REVISION INFORMATION SHEET

ONTARIO PROVINCIAL STANDARDS FOR ROADS AND PUBLIC WORKS

VOLUME 4 MUNICIPAL AND PROVINCIAL COMMON DRAWINGS FOR ELECTRICAL WORK

MANUAL REVISION #34

OPSD 2200.070

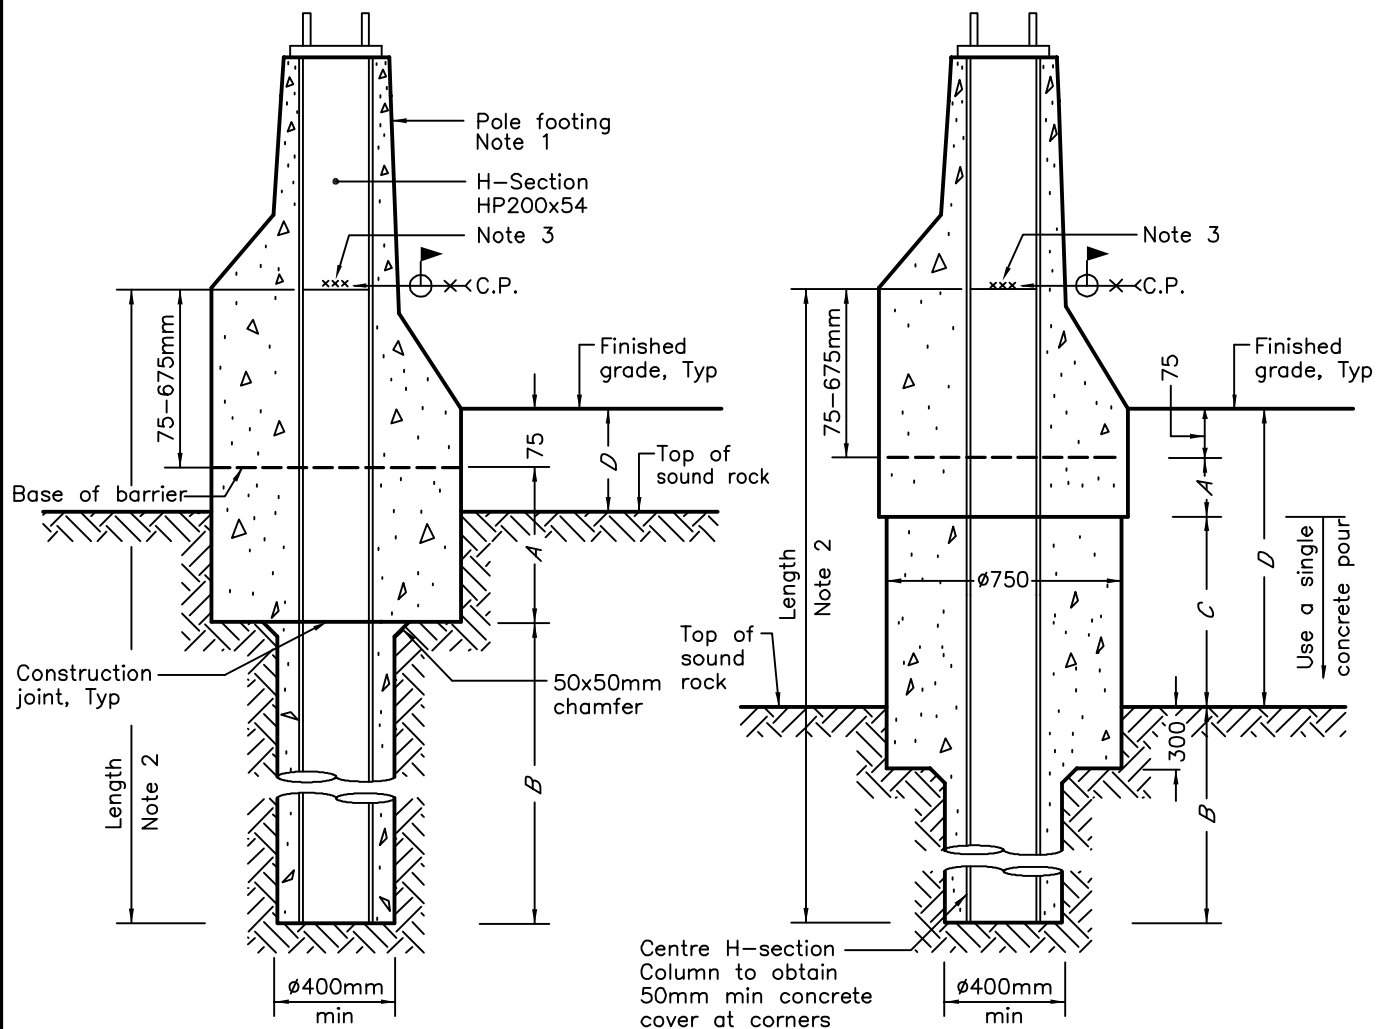
- Anchorage plate moved to top of concrete barrier.
- Section A-A, depth of duct revised from 500 mm to 450 mm min.
- Section B-B, wobble joint and concrete encasement deleted.
- Existing Note 3 deleted. Other notes reordered.
- Existing Note 4 revised.

OPSD 2200.080

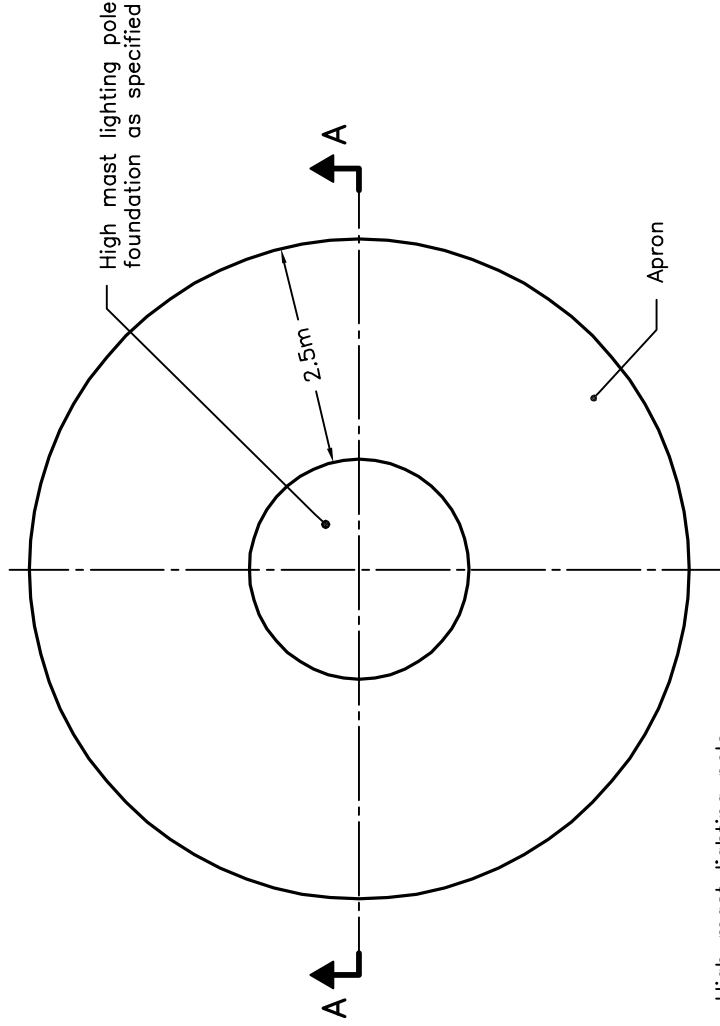
Superseded/Cancelled (Remove)		Revised/New (Insert)		Remarks
OPSD	Revision	OPSD	Revision	
2200.080	0	2200.080	1	“POLE FOOTING IN ROCK FOR CAST-IN-PLACE CONCRETE BARRIER” Anchorage plate moved to top of concrete barrier.
2210.020	1			“INSTALLATION OF DIRECT BURIED POLES IN SLOPES” OPSD Cancelled. Drawing does not add any useful information.
2210.030	0	2210.030	1	“HIGH MAST LIGHTING POLE, APRON” This drawing has been reaffirmed with no changes to technical information.
2218.010	0	2218.010	1	“HIGH MAST LIGHTING POLE, ANCHORAGE ASSEMBLY PLACEMENT” This drawing has been reaffirmed with no changes to technical information.
2225.010	0	2225.010	1	“CONCRETE LIGHTING POLE, DIRECT BURIED” This drawing has been reaffirmed with no changes to technical information.
2228.010	0	2228.010	1	“METAL LIGHTING POLE, BASE MOUNTED” This drawing has been reaffirmed with no changes to technical information.
2232.010	0	2232.010	1	“SECTIONAL STEEL POLE WITH BRACKETS, LUMINAIRE AND TRAFFIC SIGNAL HEAD” This drawing has been reaffirmed with no changes to technical information.

OPSD 2305.020

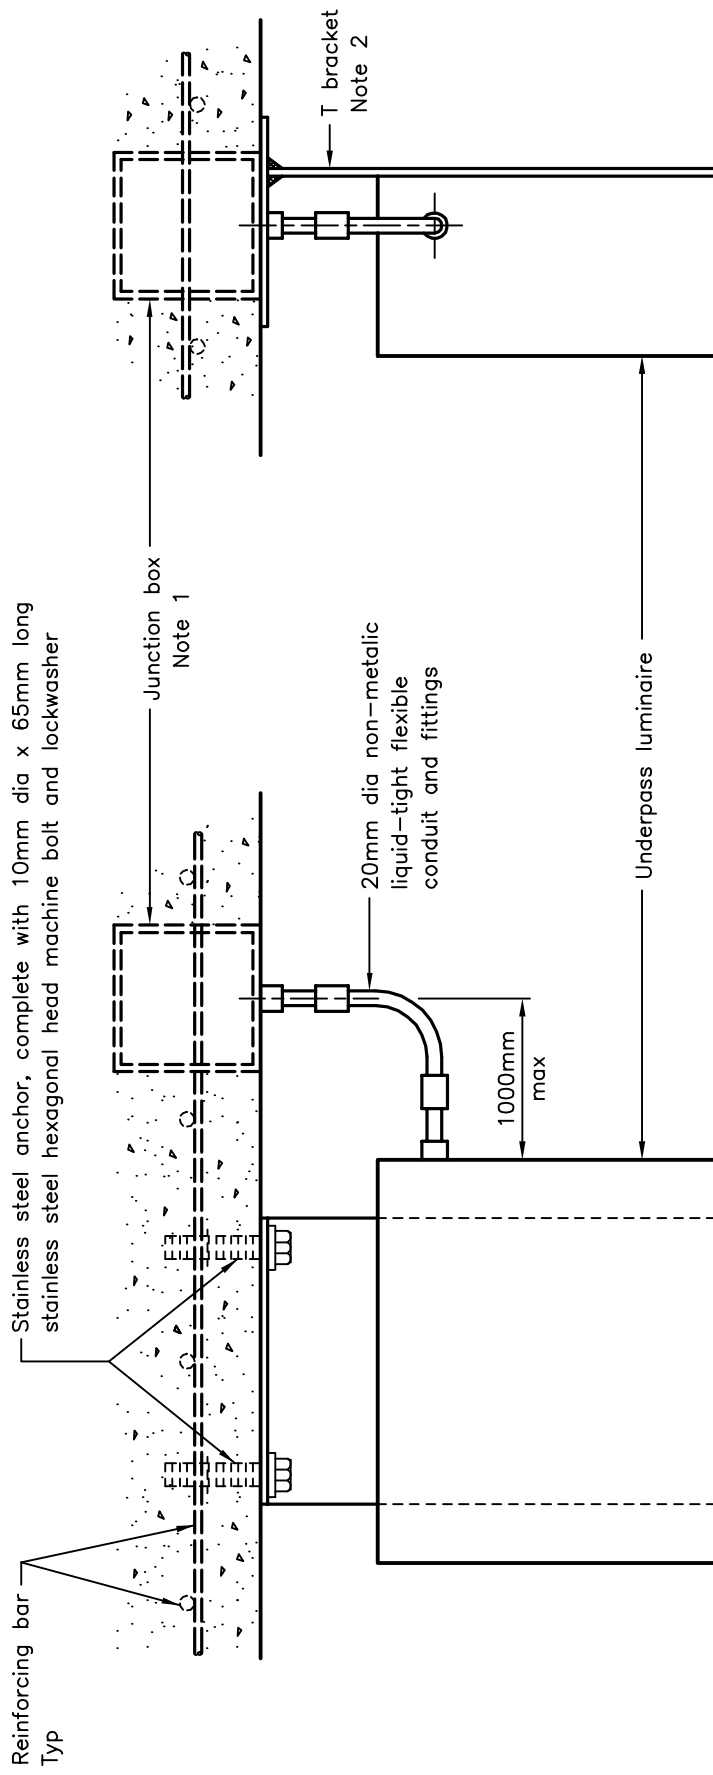
Superseded/Cancelled (Remove)		Revised/New (Insert)		Remarks
OPSD	Revision	OPSD	Revision	
2305.020	1	2305.020	2	“UNDERPASS LUMINAIRES, WALL MOUNTED INSTALLATION” Note 1 revised to specify stainless steel expansion anchors and hexagonal head machine bolts.
2310.010	0	2310.010	1	“UNDERPASS LUMINAIRE, CEILING MOUNTED INSTALLATION WITH BRACKET” See Summary of Revisions.
2310.020	1	2310.020	2	“T BRACKET FOR CEILING MOUNTED UNDERPASS LUMINAIRE” Note A revised to specify ASTM A123 for galvanizing requirements.
2310.030	0	2310.030	1	“WEDGE MOUNTING BRACKET FOR UNDERPASS LUMINAIRE” See Summary of Revisions.
2310.040	0	2310.040	1	“SUPPORT BRACKET FOR COLUMN MOUNTED UNDERPASS LUMINAIRE” See Summary of Revisions.
2315.010	0	2315.010	1	“UNDERPASS LUMINAIRE, WIRING DETAIL” This drawing has been reaffirmed with no changes to technical information.
2418.010	1	2418.010	2	“1.8M AND 2.7M STEEL TRUSS BRACKET FOR STEEL POLES” This drawing has been reaffirmed with no changes to technical information.

OPSD 2310.010

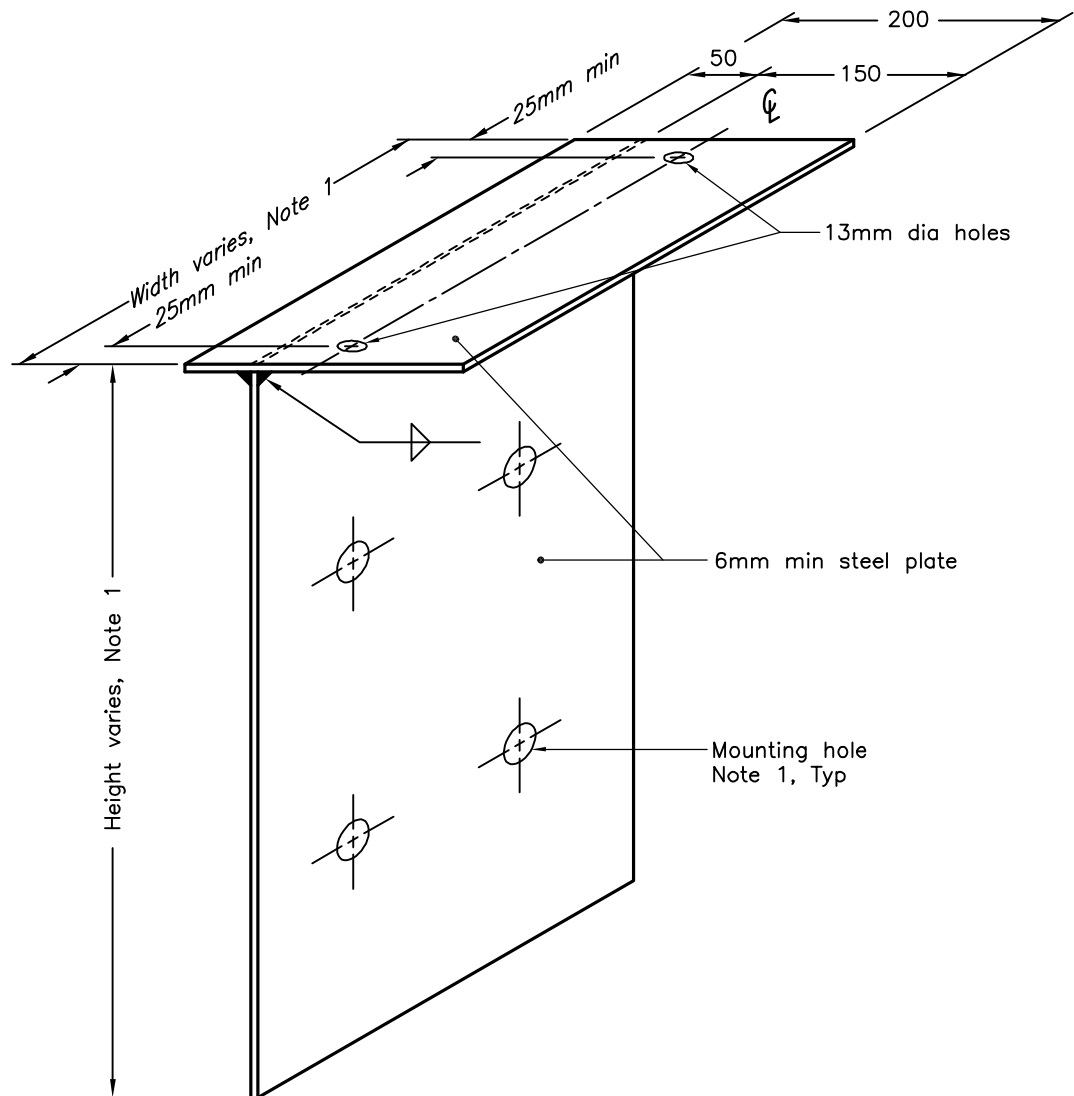
- Anchors revised from metal to stainless steel.
- Machine bolts revised to be 65 mm long with hexagonal heads.
- Reinforcing bars labelled.

ONTARIO PROVINCIAL STANDARD DRAWING	Nov 2016	Rev 1	
	HIGH MAST LIGHTING POLE 40 AND 45m 12-SIDED POLE

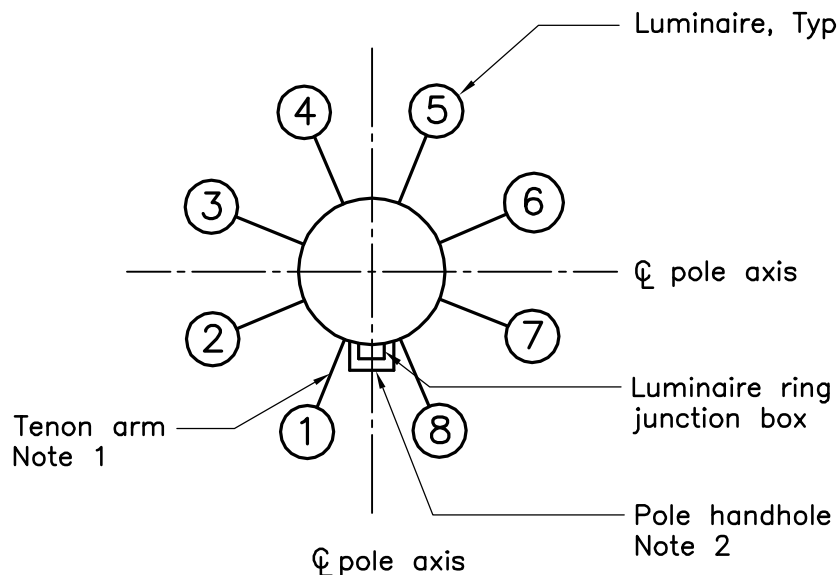
- Elevation, flat bar specified for ground stud and 42 mm pipe deleted.
- Section A-A, flat bar specified for ground stud.
- Section B-B, welding requirements revised.
- Section C-C, hole diameter revised from 52 to 57 mm.
- Detail B, back up bar deleted and welding requirements revised.
- Detail C added.
- Note A, reference to OPSD 2453.020 added.

OPSD 2453.000

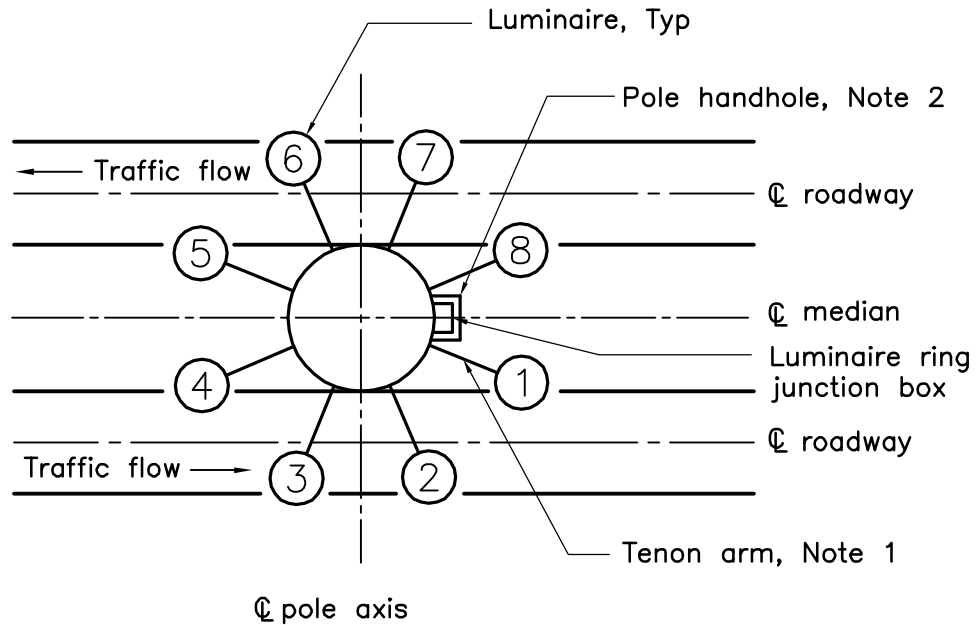
- New Note 2 added.
- Existing Note A deleted. Order notes reordered.

OPSD 2453.010

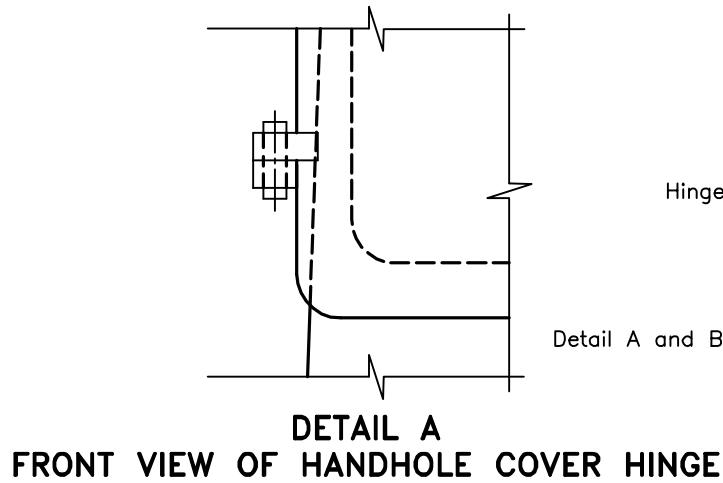
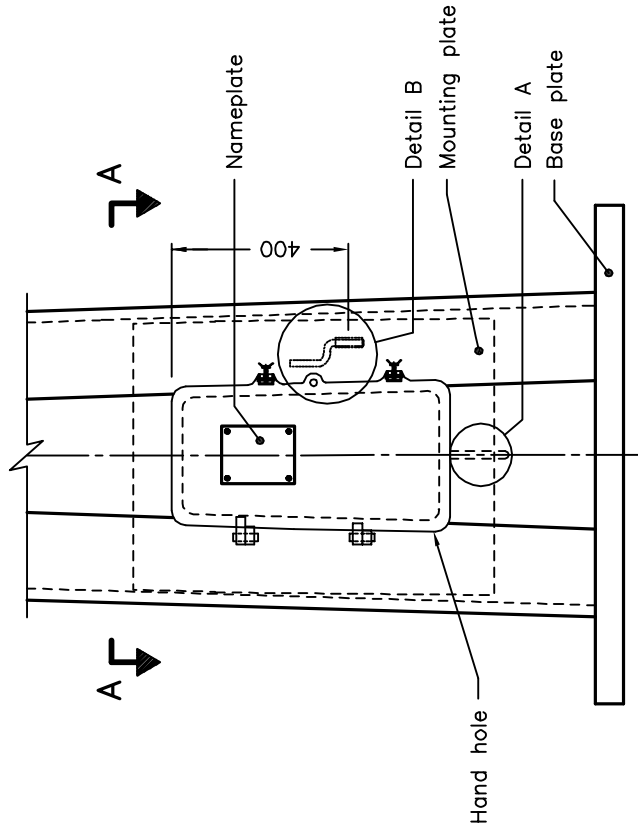
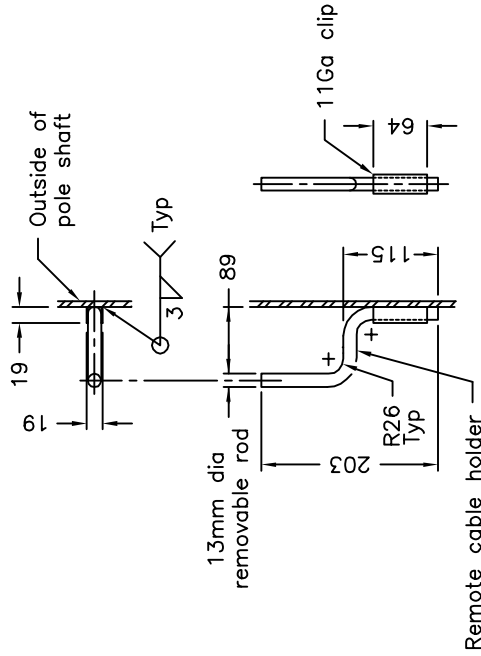
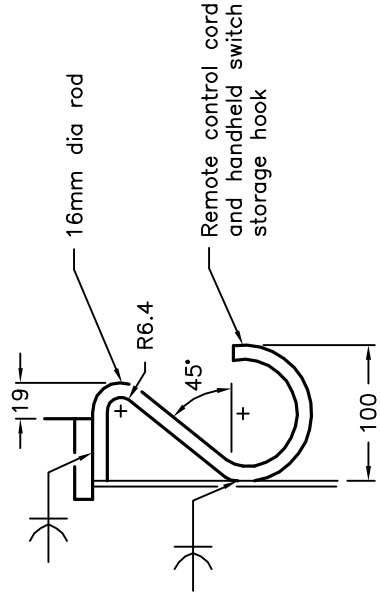
- Elevation, 42 mm pipe and Teck cable clamp deleted.
- Section A-A, Teck cable clamp deleted.
